Old Fayetteville Road to West Poplar Avenue

4-lane median divided roadway along a commercial and multifamily corridor with 20,000 daily vehicles

Location	Station	Questions	Community Workshop 2 - Feedback
Old Fayetteville Road	1	How do you think the changes will improve safety?	A. Add a protected bike intersection from 54 B. Not appreciably Signalize slip lane. Slip lane is not at all safe and cars will not look for pedestrians.
		What concerns do you have?	A. The current design consideration, with the bike lane and right turn lanes blending, are a death trap. It would be safer if the bike lane and right turn lane were separately through the intersection. B. The NRTOR currently stays illuminated five seconds. Not long enough to cross even a single side. C. Needs bike loops. How will RTOR be prohibited on a time basis? Bus stops in-between crosswalks. People cross lanes. Reduce island?
		Why do you feel this way?	A. Cars crossing the bike lane at a 90 degree angle improves visibility of cyclists and reduces pedestrian crossing time. B. I ride my bike through this intersection 3-5 times a week. No sensing loop & RTOR is too short. C. Many people on bikes won't get off to push the pe

West Poplar Avenue Design Considerations

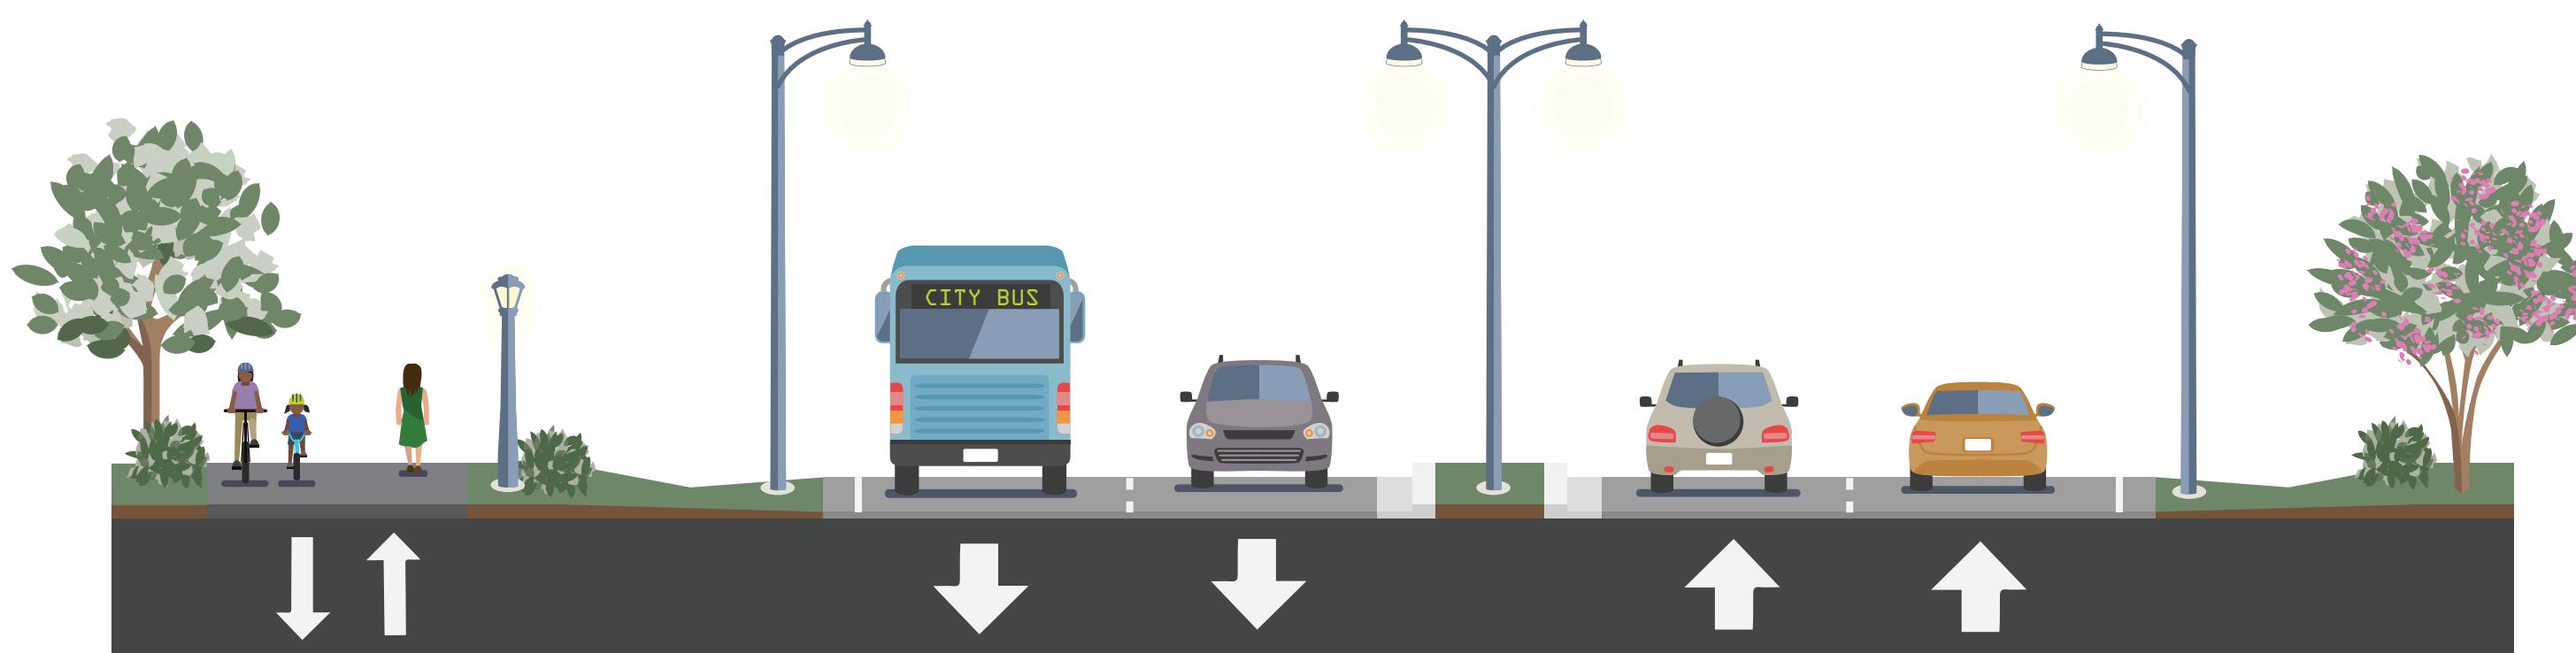
1 Prohibiting Right Turns on Red is recommended at this intersection during peak times only. Peak times would coincide with school arrival and dismissal hours, since the intersection is located near two schools, a park, shopping areas, and housing.

2 High visibility crosswalk markings are recommended at existing marked crosswalks at this intersection. These improvements will increase the visibility of pedestrians crossing between transit stops, the Carrboro Plaza, housing, and places of employment.

3 High visibility crosswalk markings with connecting sidewalks are recommended at all legs of the NC 54 and W Poplar Ave intersection. These improvements would support access to transit and pedestrian crossing at the intersection, especially those using the proposed Shared-Use Path on the east/north side of NC 54.

Pedestrian Signal Heads are recommended on the southeast and southwest corners of the intersection to clearly communicate with pedestrians when and how long they have to cross. Pedestrian signal heads are already present on the intersection corners but do not support a crossing on the south side of the intersection.

Jones Ferry Road Design Considerations

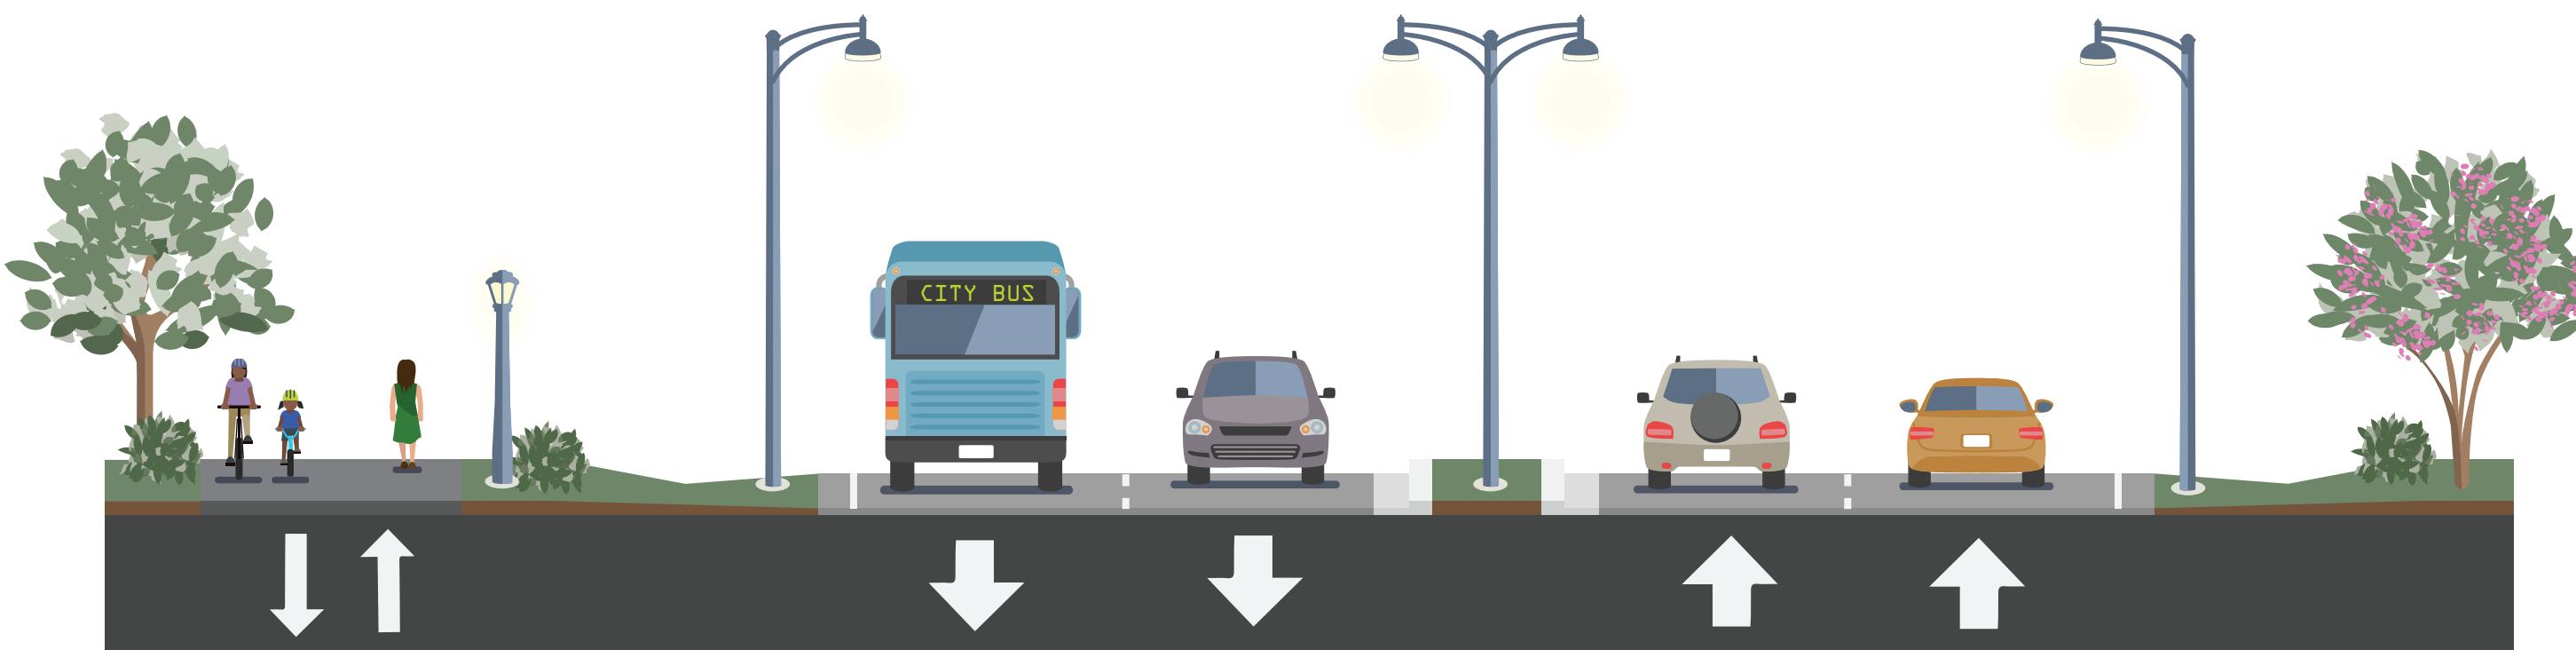
- 1 High visibility crosswalk markings, pedestrian signal phases, and pedestrian signal heads are recommended across all legs of the NC 54 westbound ramps on Jones Ferry Road. These would support pedestrians crossing Jones Ferry Road and people using the proposed Shared-Use Path on the east/north side of NC 54.
- 2 A pedestrian refuge island is recommended across Jones Ferry Road at the NC 54 westbound ramps. The refuge island would provide pedestrians and bicyclists a place to wait if they were unable to cross Jones Ferry Road in one stage. The pedestrian refuge island would also support the proposed Shared-Use Path on the east/north side of NC 54.

- 3 Modifying the intersection from an unsignalized left-in, right-out intersection to one with a signal is recommended at NC 54 and Westbrook Drive. The change to a signalized intersection would include the addition of a traffic signal that—when activated—would allow pedestrians to cross NC 54 at marked crosswalks in one WALK phase.
- 4 The addition of sidewalks and relocation of Chapel Hill Transit bus stops are recommended on the northeast and southwest corners of the intersection. Moving the bus stops from the existing locations to the proposed locations would better integrate with the proposed signalized intersection and encourage crossing at the marked crossing locations.

Smith Level Road Design Considerations

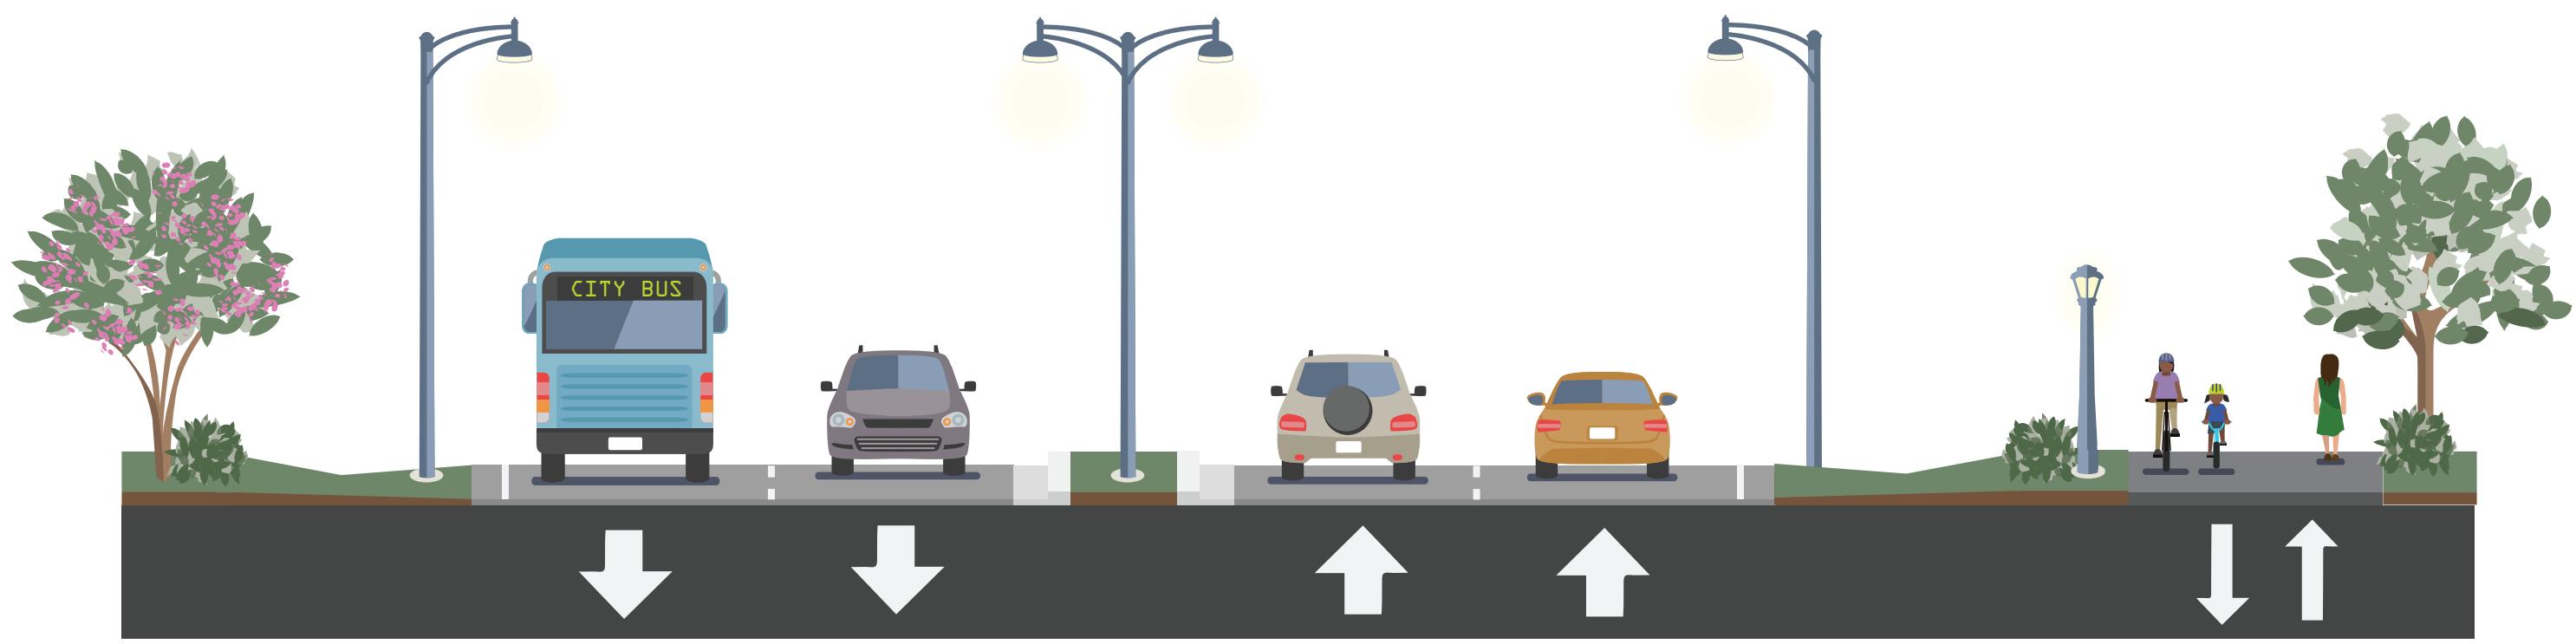
- Modifying the intersection from an unsignalized left-in, right-out to a signalized left-in, right-out intersection with pedestrian accommodations is recommended at NC 54 and the entrances to Abbey Lane. Changing the intersection would include the addition of a traffic signal that—when activated—would allow pedestrians to cross NC 54 at marked crosswalks in one WALK phase.
- The addition of sidewalks and relocation of Chapel Hill Transit bus stops are recommended on the northeast and southwest corners of the intersection. Moving the bus stops from the existing locations to the proposed locations would better integrate with the proposed signalized intersection and encourage crossing at the marked crossing locations.

- High visibility crosswalk markings and pedestrian signal phases are recommended across all legs of the NC 54 eastbound ramps on Smith Level Road. These improvements would support pedestrian access across Smith Level Road and NC 54.
- Pedestrian Signal Heads are recommended on the four corners of the Smith Level Road and NC 54 eastbound ramps to clearly communicate with pedestrians when and how long they have to cross. Pedestrian signal heads are already present on Smith Level Road at the entrance to Frank Porter Graham Elementary.

Kingswood & Laurel Ridge Design Considerations

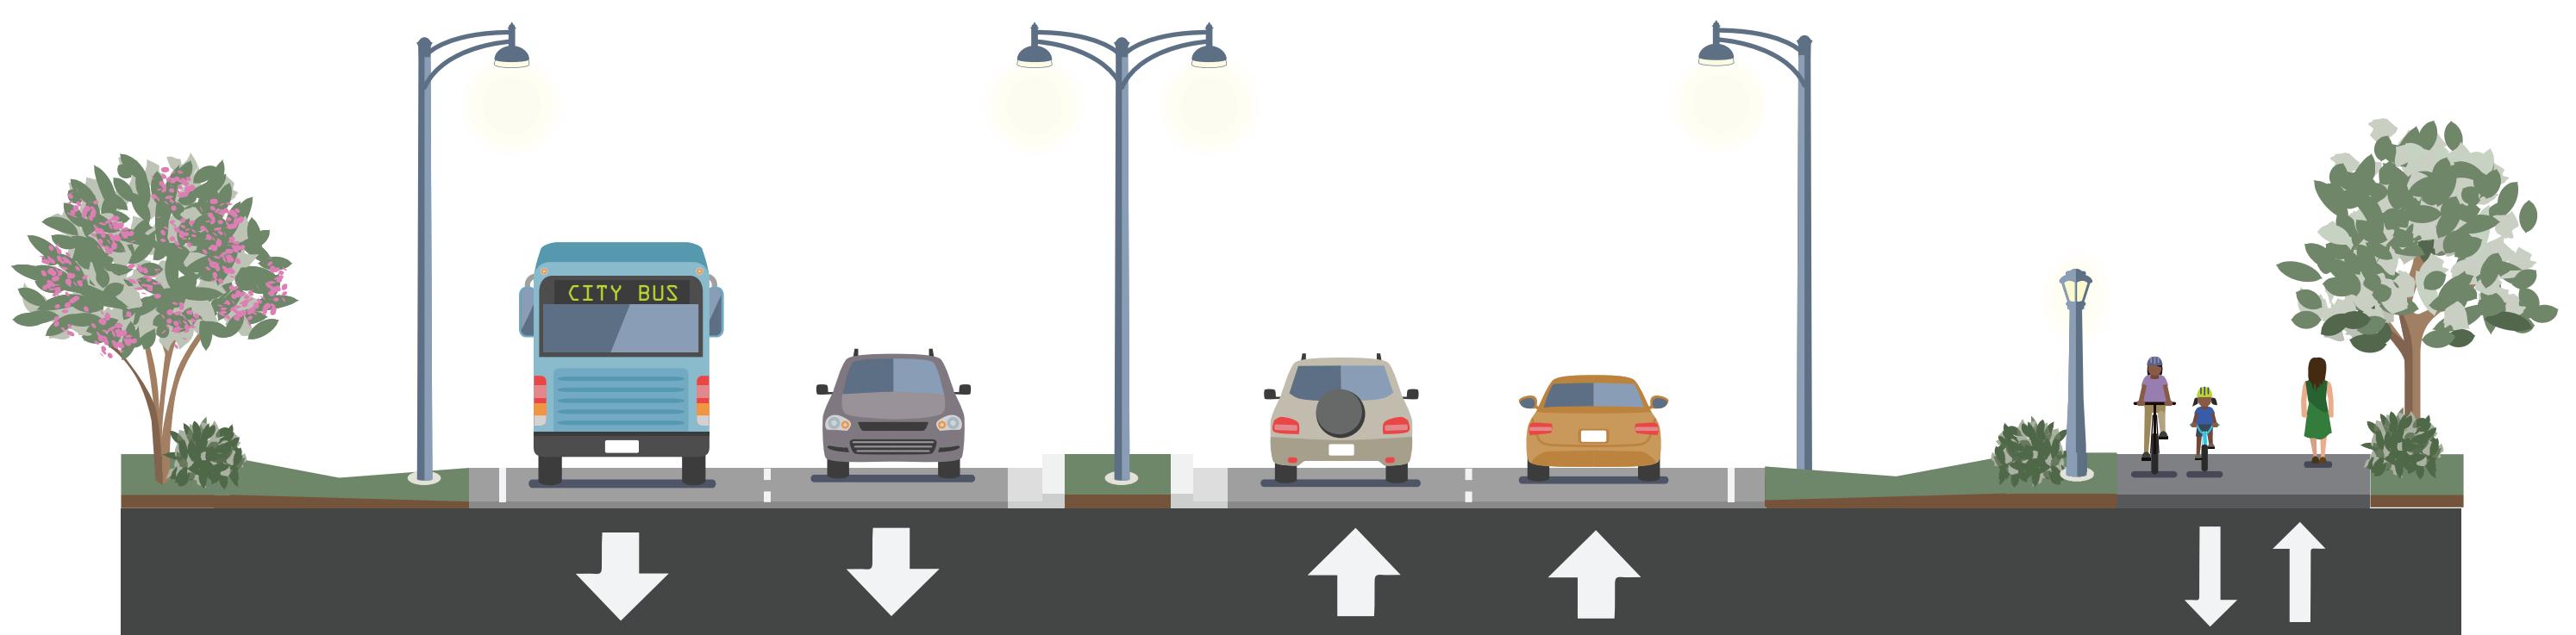
- Modifying the intersection from full access to a left-in, right-out intersection is recommended at NC 54 and the entrances to Laurel Ridge and Kingswood Apartments. Changing the intersection would include the addition of a traffic signal that—when activated—would allow pedestrians to cross NC 54 at marked crosswalks in one WALK phase while also improving safety for vehicles by lowering risk of angle crashes.
- The addition of sidewalks and relocation of Chapel Hill Transit bus stops are recommended on the northeast and southwest corners of the intersection. Moving the bus stops from the existing locations to the proposed locations would better integrate with the proposed signalized intersection and encourage crossing at the marked crossing locations.
